**SUBJECT: Upfit Body Mounting Guidelines**  
**MODEL YEARS: 2024 & Beyond**  
**AFFECTED MODELS: UU Model THREE**  
**INITIATION DATE: 08/29/2023**  
**REVISION: 10/05/2023**

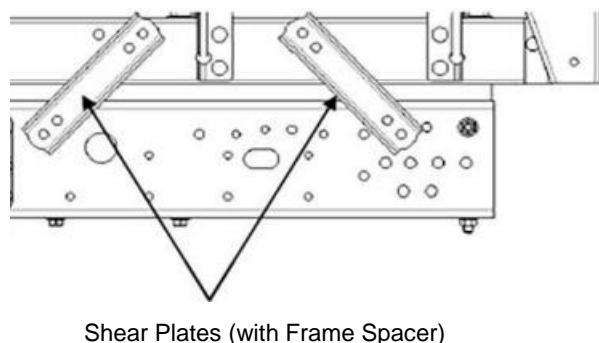
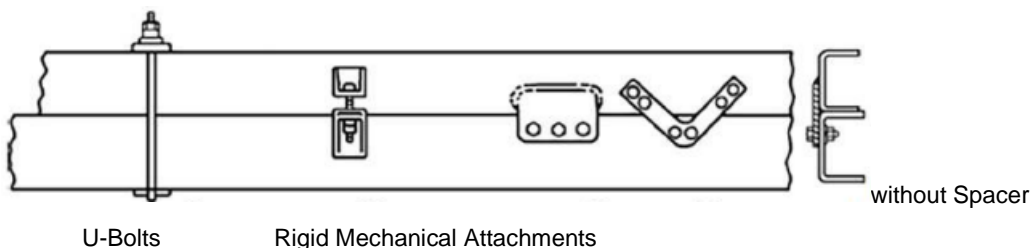
- Improper Upfit Body mounting practices may not distribute load over the entire chassis while liberal use of Shear Strap and U-Bolt placement could result in a mechanical attachment issue that may impact safe best practices.
- Upfit equipment to close to HIGH VOLTAGE Battery Assemblies.
- Inadequate clearance from the back-of-cab to the upfit body could impede access to under cab servicing and access to chassis components.

Proper Upfit Body mounting secures and distributes load over the entire chassis for rigid attachment of Upfit Body to chassis. Continuous mechanical contact to the frame rails fore and aft of the rear axle is necessary for proper load transfer and distribution. Full perimeter use of the load bearing top-of-frame surface contact with hardwood spacers (or equivalent) is strongly recommended. Generous use and placement of U-Bolts and Shear Plates utilizing existing frame rail holes insure proper mechanical attachment. Use proper premium grade fasteners for rigid mechanical attachment of Upfit Body to chassis mounting areas. Welding is permitted in low stress areas of the frame (aft of rear spring shackles).

Acceptable types of attachments.

• **Regarding HIGH VOLTAGE Batteries/Components & Wiring.**

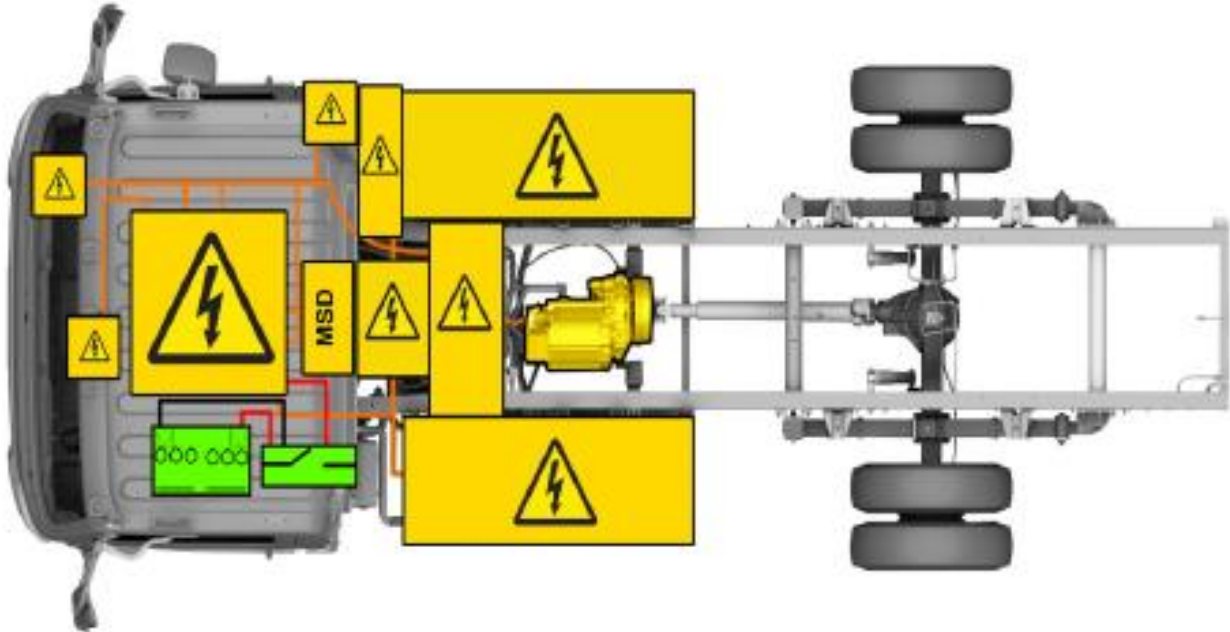
- 1) Maintain a minimum static clearance of 150mm / 3” between frame rail mounted HIGH VOLTAGE Batteries/Components/Wiring and Upfit Body/Equipment.
- 2) Do not alter or relocate HIGH VOLTAGE components from the OEM chassis location.
- 3) Do not mount Upfit Body/Equipment to the HIGH VOLTAGE Batteries/Components/Wiring.
